Dist	COUNTY	ROUTE	KILOMETER POST TOTAL PROJECT	SHEET No.	TOTAL SHEETS
04	SF,Ala	80	12.7/14.3, 0.0/2.7	43R1	84

CONTRACT CHANGE ORDER No. 170
SHEET ___ OF ___

ROADWAY LEVEL WESTBOUND
LIGHTING AND ELECTRICAL SYSTEMS
SCALE: 1:200

ROADWAY LIGHTING POLE PLAN LOCATION-SHEET 22
SKYWAY STRUCTURES
NO SCALE

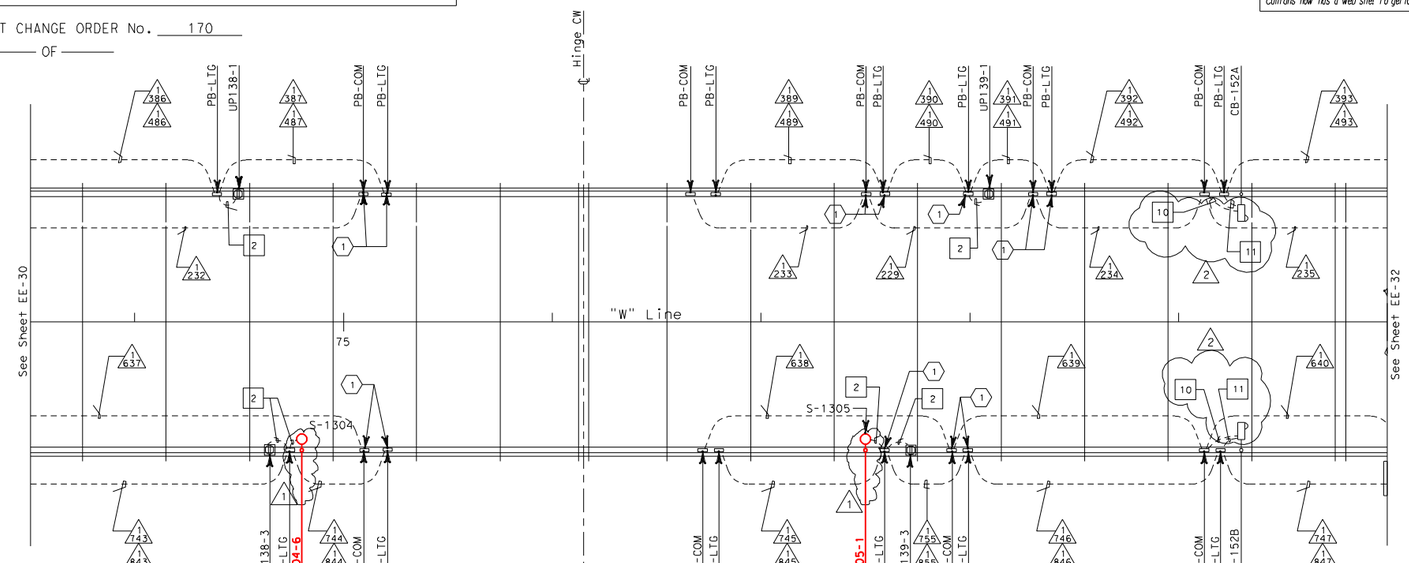
MARK	DATE	DESCRIPTIONS	REV	CK	
2	1/20/06	Delete CB-152A & CB-152B. Coil 5 m of call box signal and power cable in adjacent PB-COM and PB-LTG pull boxes.	JE	EJL	CCO No. 170
1	3/2/05	Delete Roadway light poles and fixtures. Coil 10m, 3#10 conductors in the pull box adjacent to light pole locations.	RS	PB	CCO No. 123
